Origination Form
Proposed Revisions to a Standard Plans Index

Originator:	Meyer, Ronald and Lemus, Vivian	Index Number:	700-120
Date:	6/22/2026	Sheet Number(s):	1,2,5,6,7
E-mail:	Ronald.Meyer@dot.state.fl.us	Index Title:	ENHANCED HIGHWAY SIGNING ASSEMBLIES

UPDATED Table of Contents

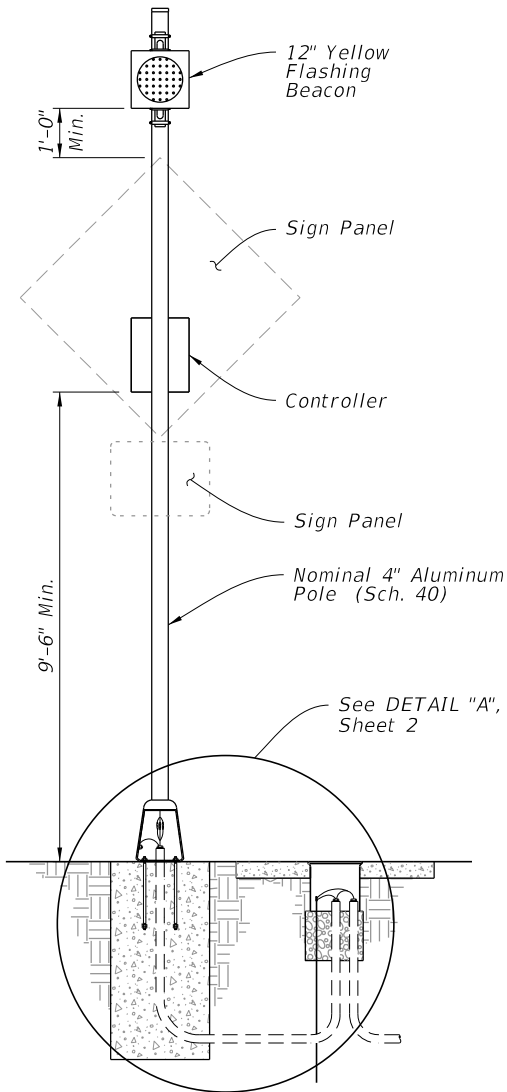
Sheet 1: Updated the Table of Contents.

DETAIL "A"

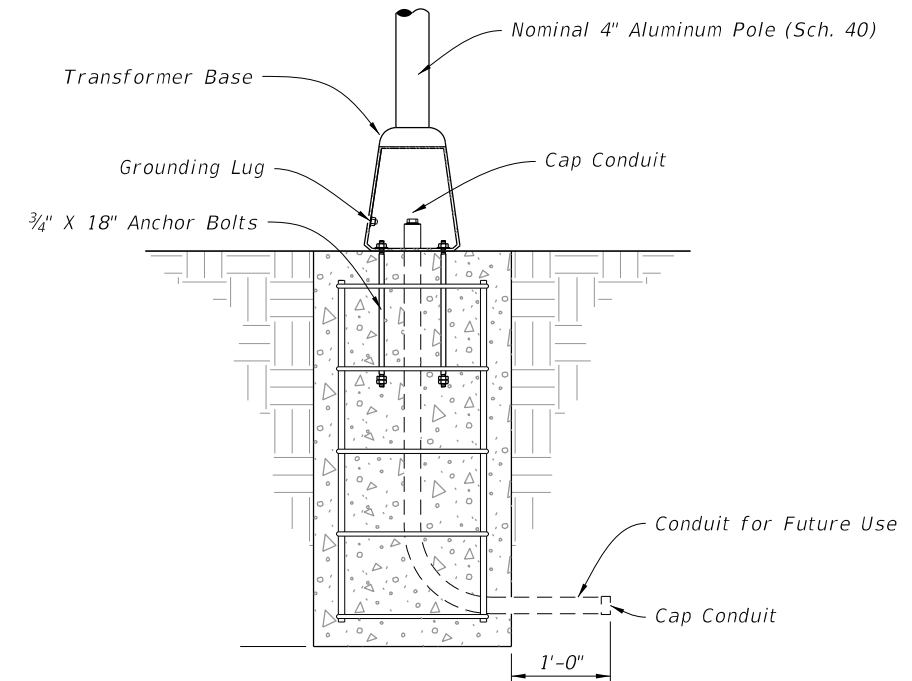
Sheet 2: Updated electrical component in Detail "A"

~~One Pole, Non Fused, Watertight Breakaway Electrical Connectors~~

~~One Pole, Non Fused, Watertight Breakaway Electrical Connectors~~

Sheet 2 - To improve the electrical safety and operational reliability of Enhanced Highway Signing Assemblies. The change reduces the likelihood of energized conductors being exposed after a knockdown event, minimizes equipment damage, and enhances overall system safety.

LAST REVISION	DESCRIPTION:	FDOT	FY 2026-27 STANDARD PLANS	ENHANCED HIGHWAY SIGNING ASSEMBLIES	INDEX 700-120	SHEET 5 of 13
11/01/25

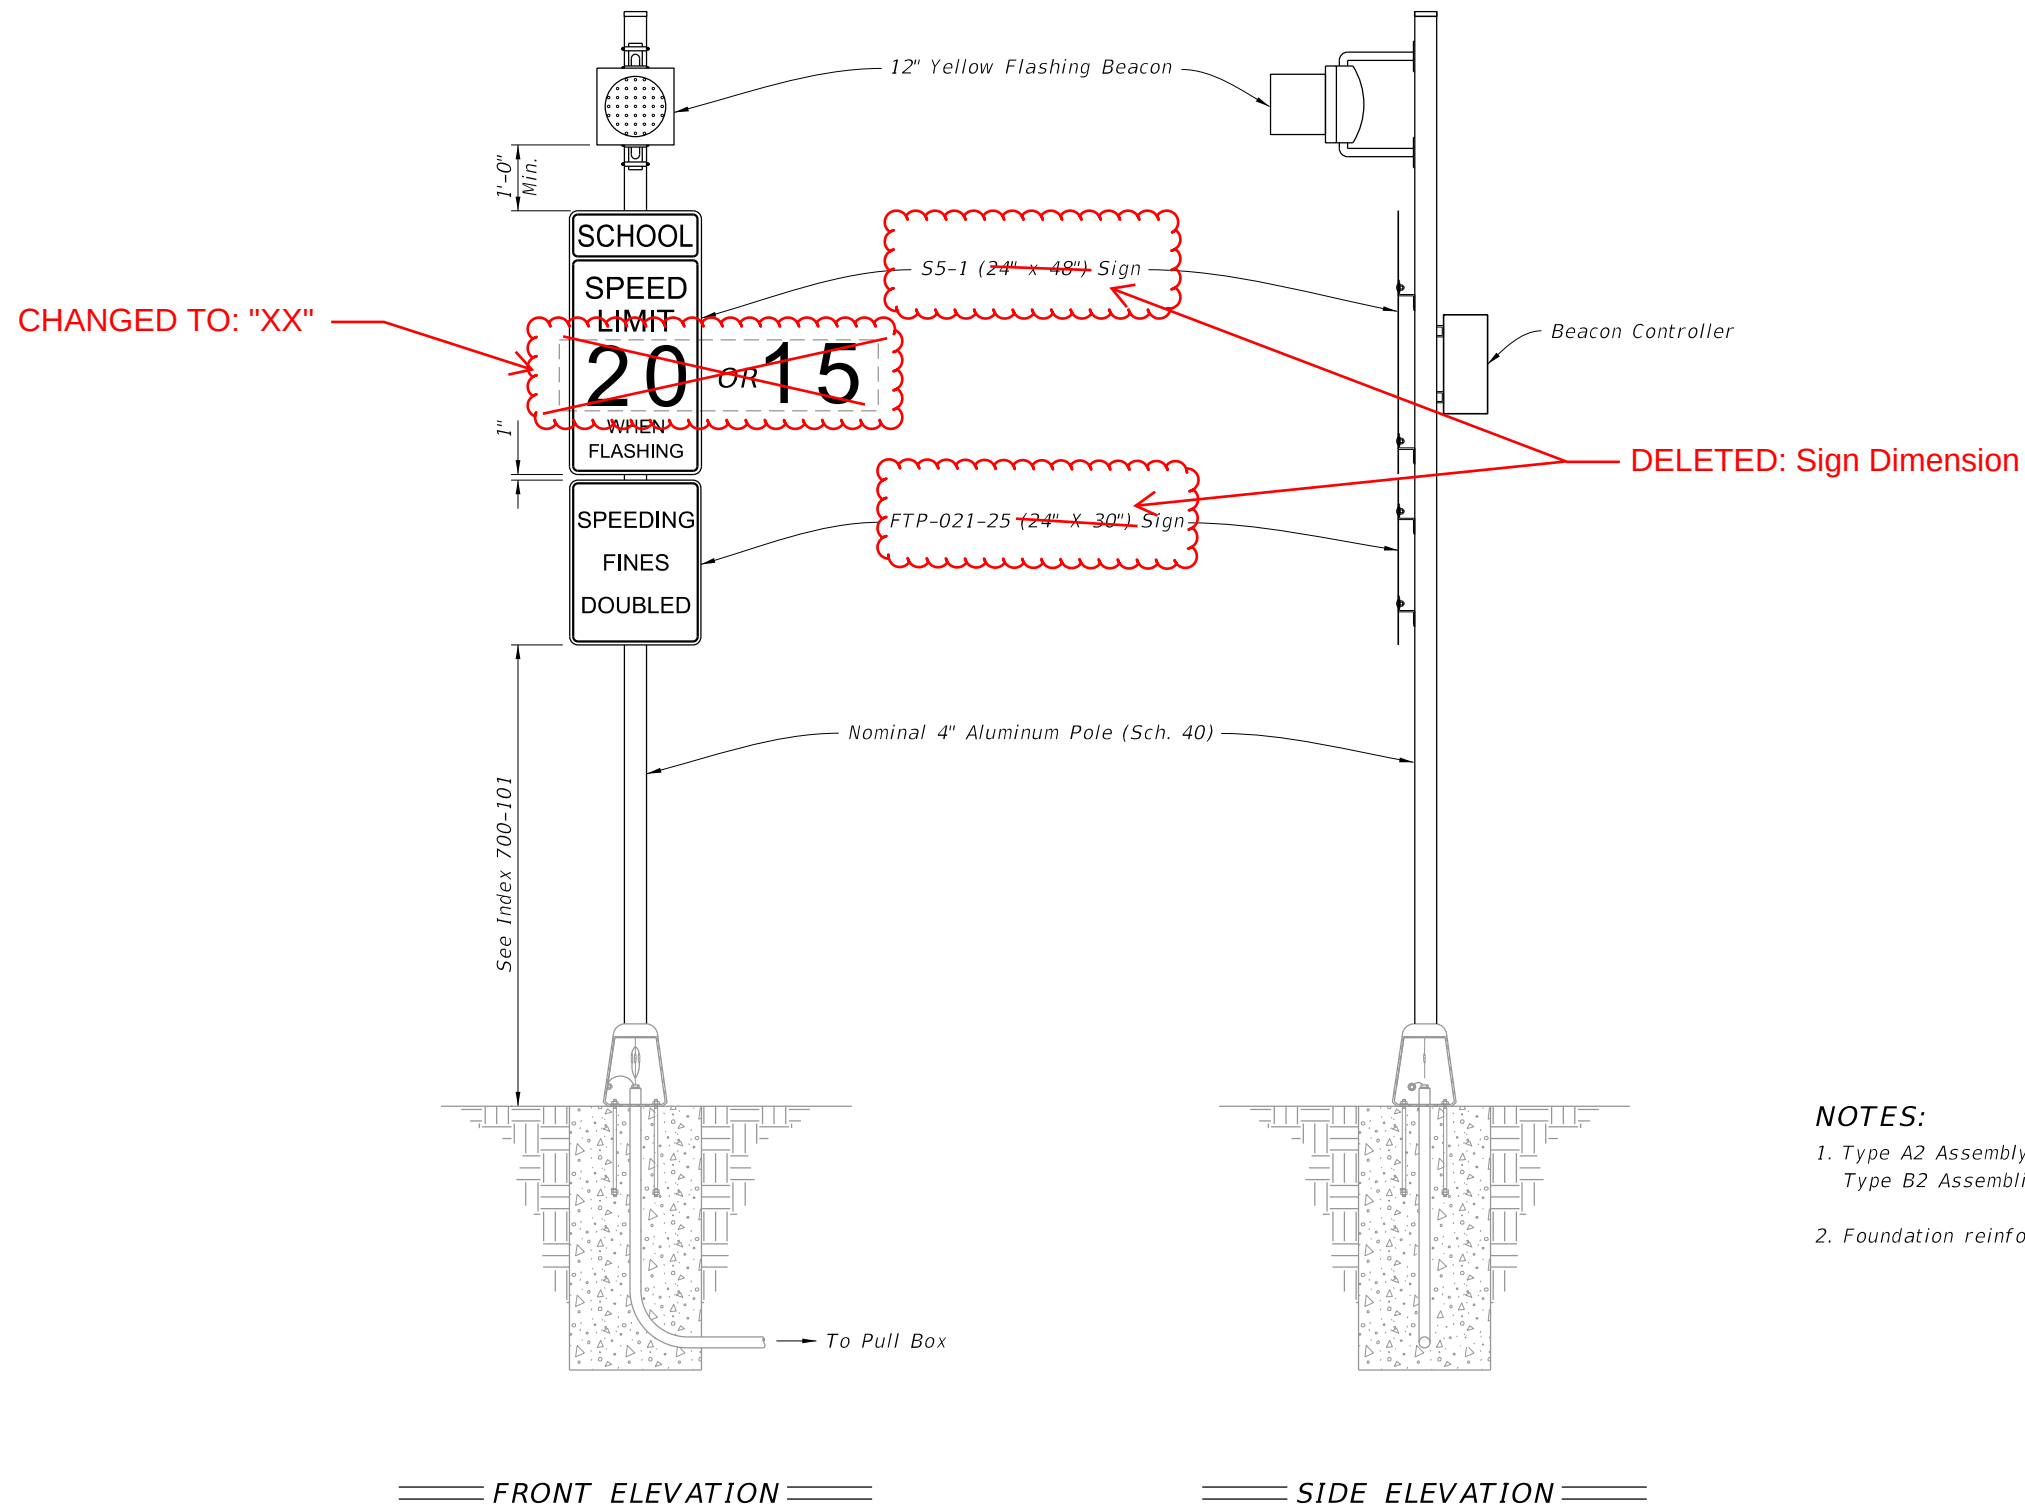
Sheet 5: Deleted dimensions for S5-1 and FTP-021-25; Changed the speed limits from "20 or 15" to "XX" to match figures in upcoming release of Speed Zoning Manual.

Sheet 5 - should be updated to remove specific dimensions for S5-1 and FTP-021-25 and clarify that speed limits can be other than 20 or 15 as appropriate (recommend changing to "XX" to match figures in upcoming release of Speed Zoning Manual); Added Callout & S4-3P Sign.

ROADSIDE SIGN ASSEMBLY-4

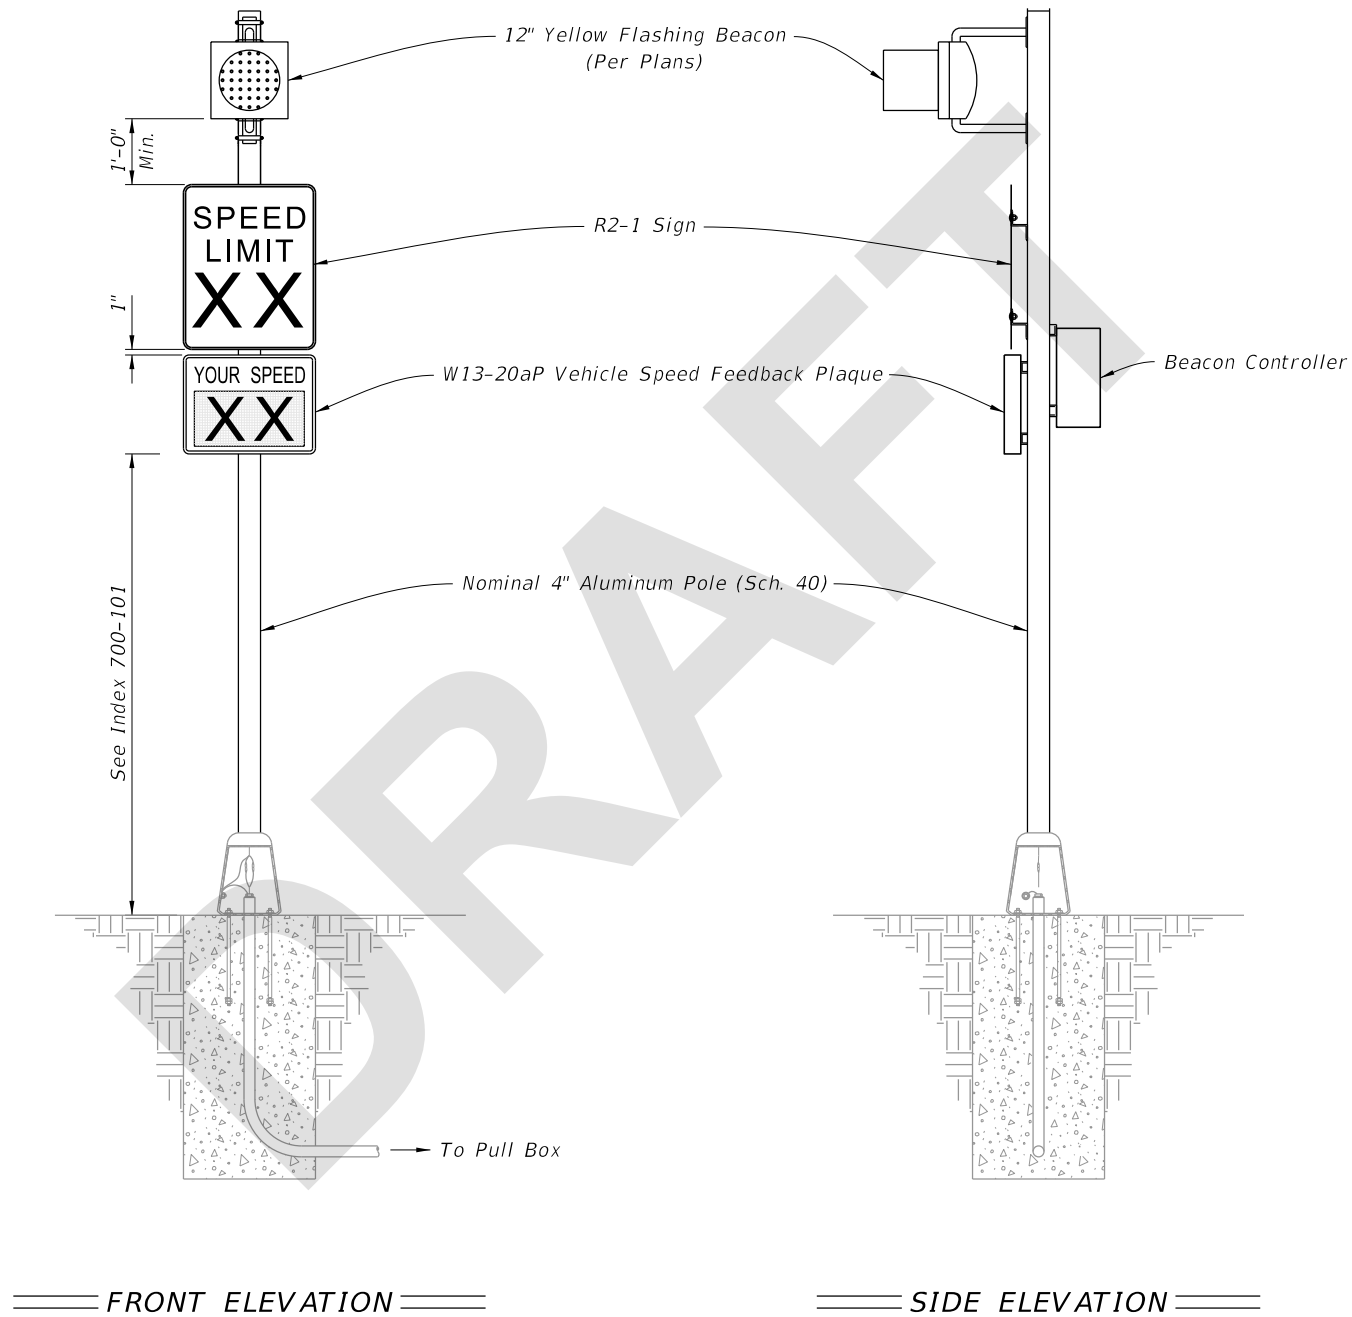
Sheet 7 (New Sheet 6): Added "(Per Plans) to the 12" Yellow Flashing Beacon callout; Deleted dimensions for R2-1; Updated the "Electronic Speed Feedback Sign" to "W13-20aP Vehicle Speed Feedback Plaque; Updated the "Your Speed" sign to match the shape and size of the W13-20aP Vehicle Speed Feedback plaque as required and shown in the latest MUTCD; Deleted Note 2

Sheet 7 - (New Sheet 6) must be updated to better match the shape and size of the W13-20aP plaque as required and shown in the latest MUTCD. The TERL has been in contact with speed feedback sign vendors listed on the APL regarding both standalone signs and plaques. Vendors are aware of the MUTCD changes and their need to comply with MUTCD requirements to have products listed on the APL. Note 2 - reflect the reference to SHS and MUTCD
